ARCHITECT'S ADDENDUM TO THE CONTRACT DOCUMENTS

ADDENDUM NO: Two (bidder's questions)
DATE: Wednesday, May 1, 2024
PROJECT: 23-133 AIM CENTER OF EXCELLENCE AT SLN
OWNER: SALINA AIRPORT AUTHORITY
2720 ARNOLD AVE
SALINA, KANSAS
ARCHITECT: ARCHITECT ONE
906 S KANSAS AVE, STE 200
TOPEKA, KANSAS

3 Demolition Roof Plan
SCALE: 1/8" = 1'-0"

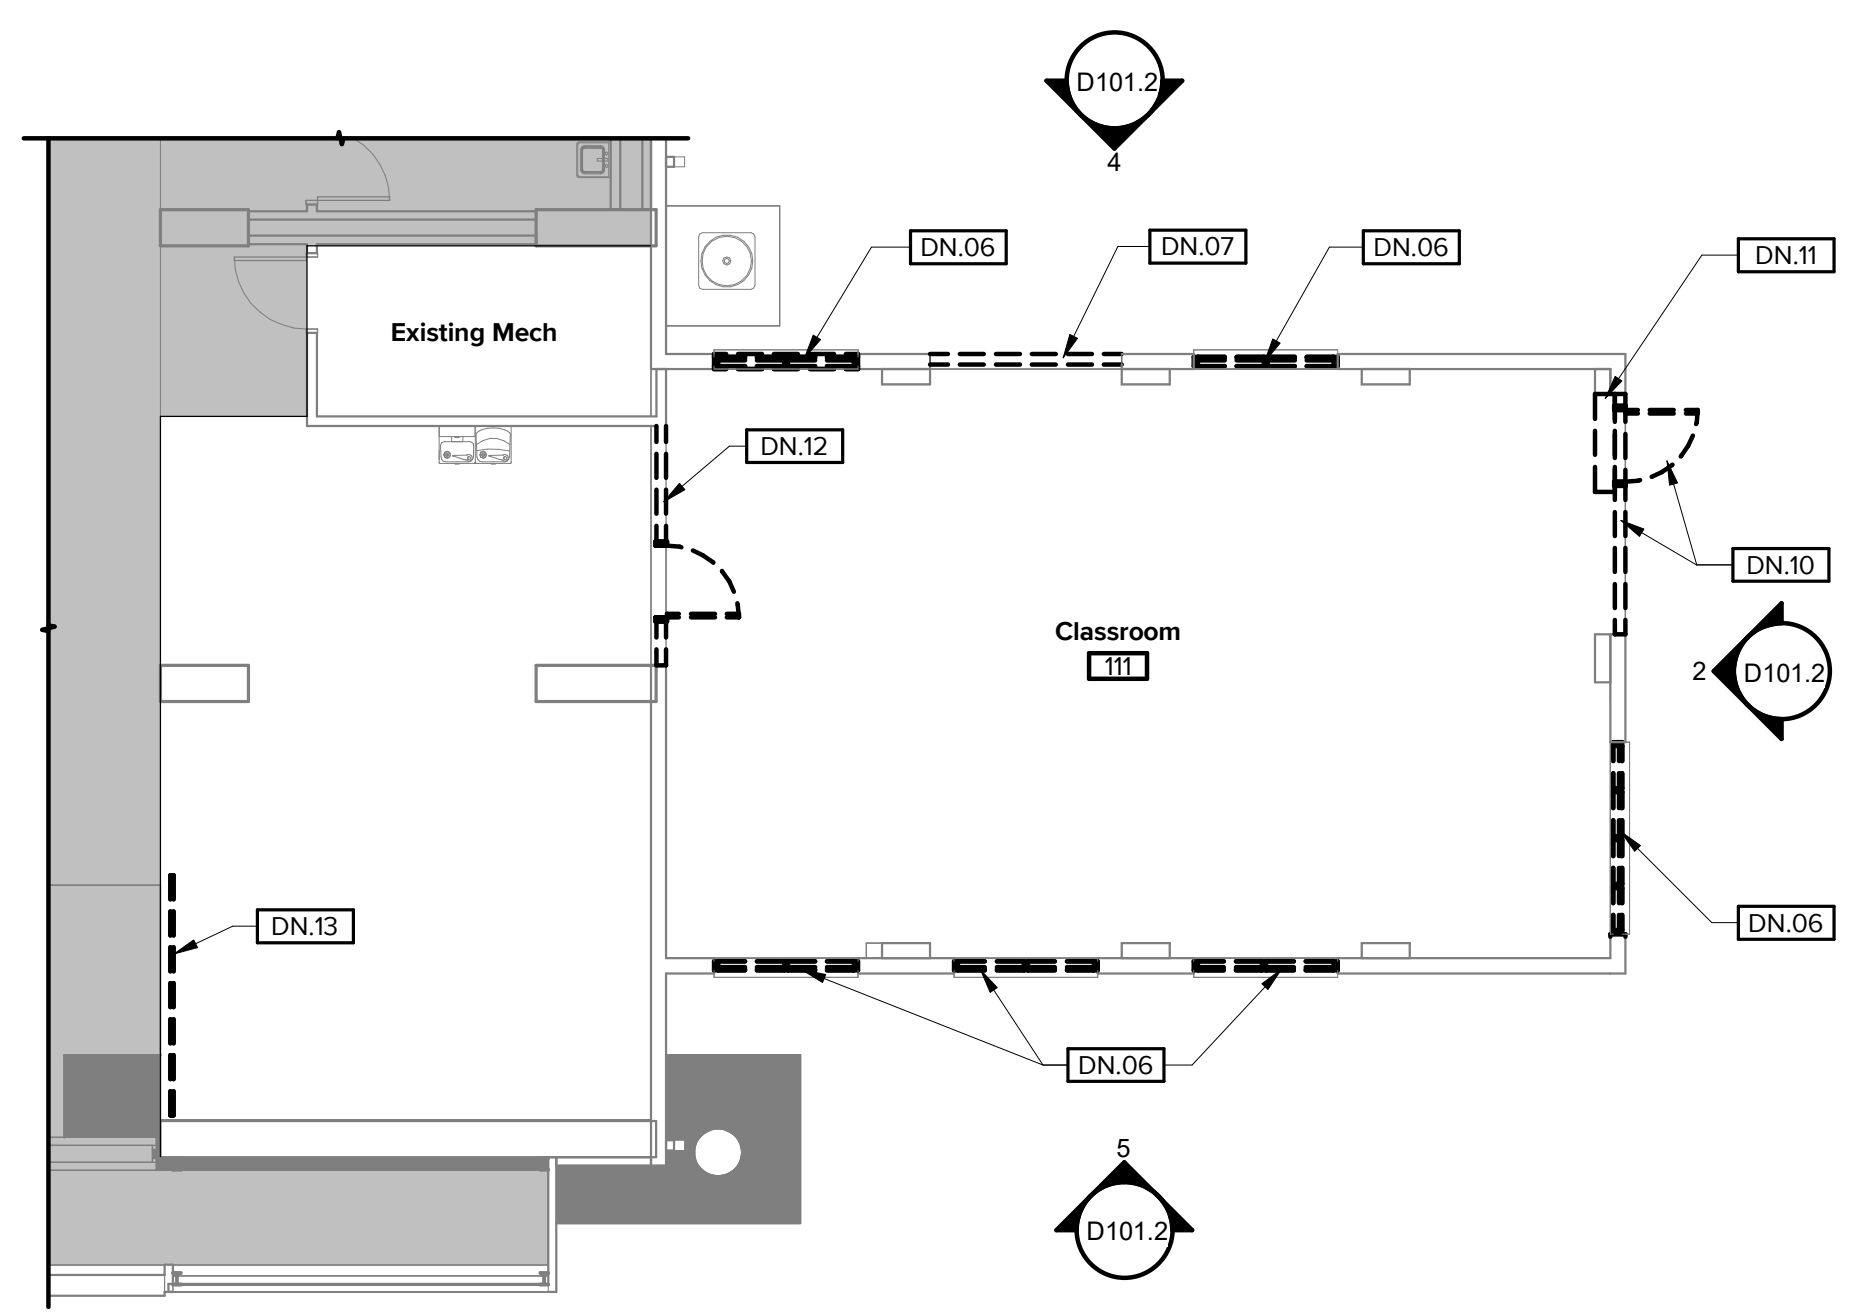
4. 3/D101.2 Roof Demolition Plan indicates for roof to be removed down to 1x decking. 4/A511.2 Low Eave Detail indicates 5/8" decking with asphaltic primer. Is the existing decking to remain or is new 5/8" decking to be provided?

- o *Answer: New 5/8" decking is to be provided. Note DN.08 on Roof Demolition Plan has been updated.*
5. Will a spec section for the signage be issued?

DN.06	REMOVE GLAZING ASSEMBLY AND PREPARE OPENING FOR NEW WINDOW
DN.07	REMOVE PORTION OF WALL AND PREPARE OPENING FOR NEW CONSTRUCTION
DN.08	REMOVE EXISTING ASPHALTIC ROOFING, METAL EAVE AND RAKE TRIM, WOOD FASCIA, AND ANY UNDERLAYMENT, AND IX DECKING. COMPLETE TEAR OFF DOWN TO WOOD TRUSSES.
DN.09	REMOVE GABLE VENT AND PREPARE OPENING FOR WALL INFILL
DN.10	REMOVE PORTION OF WALL AND DOOR AND PREPARE OPENING FOR NEW GLAZING ASSEMBLY
DN.11	REMOVE CONCRETE RAMP/SILL AT EXISTING ENTRY DOOR
DN.12	REMOVE TEMPORARY WALL AND DOOR. SALVAGE DOOR TO OWNER
DN.13	REMOVE GUARDRAIL AND SALVAGE TO OWNER
